Comments on the Applicant's D1 Submissions

This document sets out the comments by Cambridgeshire County Council (**CCC**) on the Applicant's Deadline 1 (**D1**) submissions. The table below provides the relevant paragraph or other references used in the submissions.

Revised Construction Traffic Management Plan [REP1-035]

**VIEWPORT 1: Site Access Arrangement
(Accesses SA14 & SA15 - Visibility Splays)**

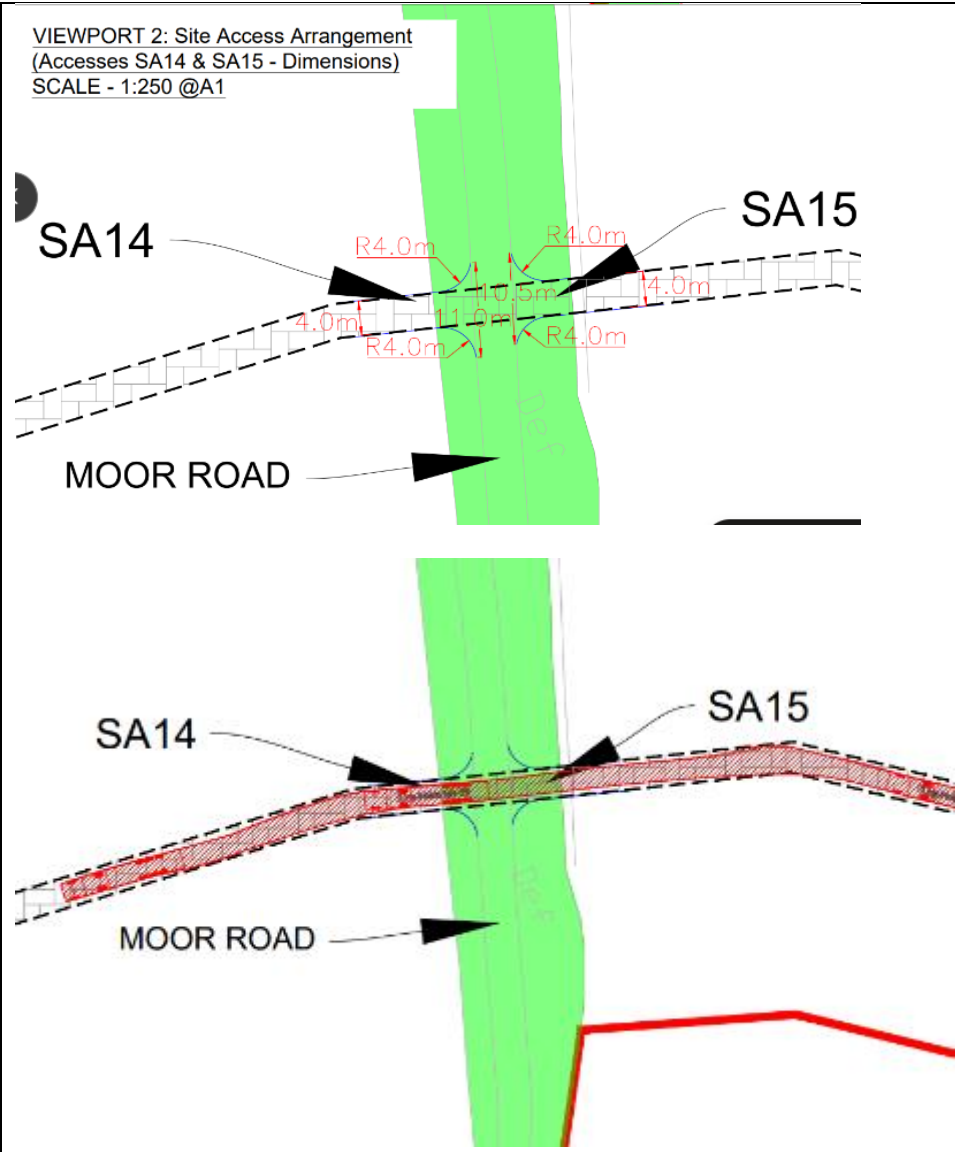
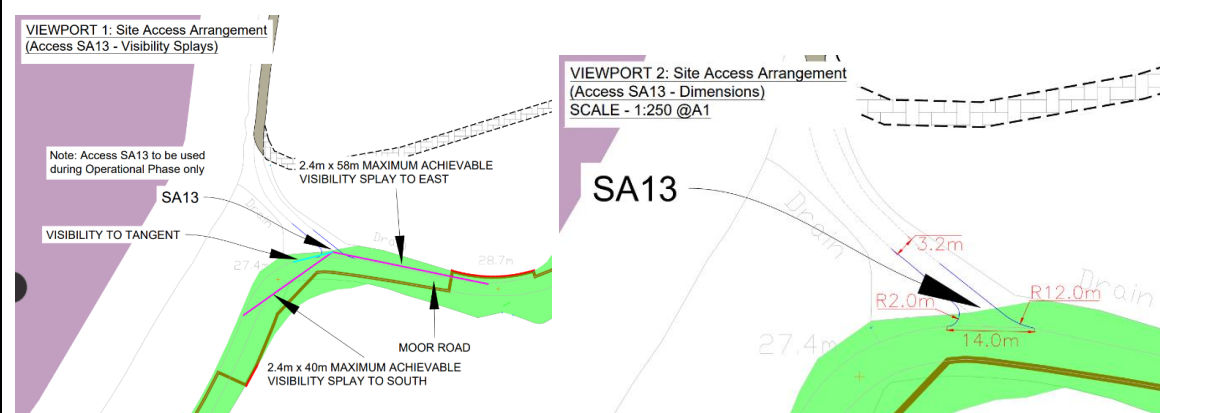
7.1.1	Each access should have a non-granular surface for a reasonable distance from the road edge where, if required, cleaning stations may be located.
Access drawing comments.	SA14 and SA15 Construction only accesses / crossing point	Visibility requirement has not been met as indicated before, the recorded speeds are above those required to assess by Manual for Streets requirements i.e. above 37mph. It is noted, however, that the speed surveys were carried out remote from the location of this crossing. Therefore, either further speed surveys will be required, or temporary traffic regulation orders would be required to reduce the speeds of vehicles with appropriate warning signage.

VIEWPORT 2: Site Access Arrangement
(Accesses SA14 & SA15 - Dimensions)
SCALE - 1:250 @A1

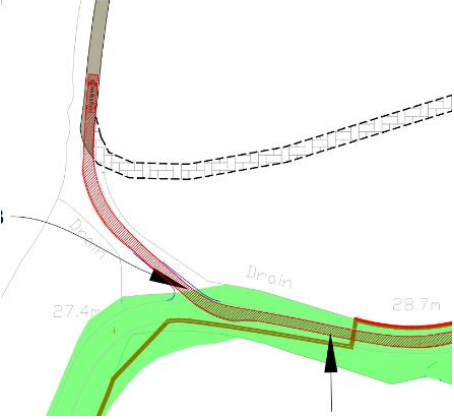
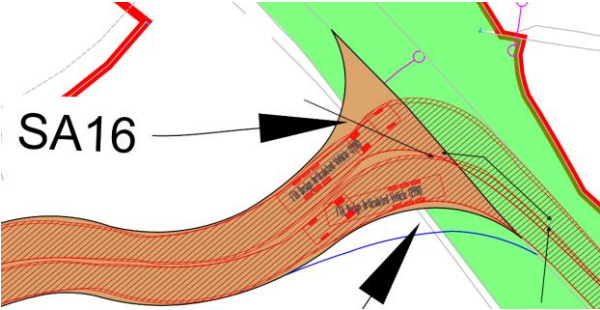
With regards to the access width, it is noted that two vehicles are unable to pass at the location of the crossing with a 4m width. The crossing should be of sufficient width to allow two-way simultaneous movements at locations adjacent to the highway. While it is indicated within the CTMP that vehicles will be controlled so that none should meet, this safeguard should be built in as standard to mitigate for such instances.

<p>The council queries why 4m radii have been applied to the design. As no vehicles are proposed to use Moore Road, the inclusion of these would only seem to allow manoeuvres. The council requests that the applicant removes these to ensure straight across movements only. Moore Road has limited width to accommodate construction traffic for the project.</p>
	<p>SA13 operational access</p>	<p>Whilst this is an existing access, the council has not seen any information relating to the existing use and or proposed use, so requests clarity on whether there will be additional volume.</p> <p>The proposed splays are also indicated but no speed measurements have been undertaken in this location to ascertain if they are adequate.</p> <p>The tracking has been undertaken with a 10m rigid vehicle – the council requests clarity as to whether this is the largest vehicle likely to use the access, with details provided of the frequency to ensure the single width nature is acceptable.</p> <p>The council also notes that it is not a balanced junction regarding radii, and requests further information as to whether any vehicles using the access will only enter and leave from the North.</p>

A width of 7.3m for a distance of 20m from the road edge should be sufficient.
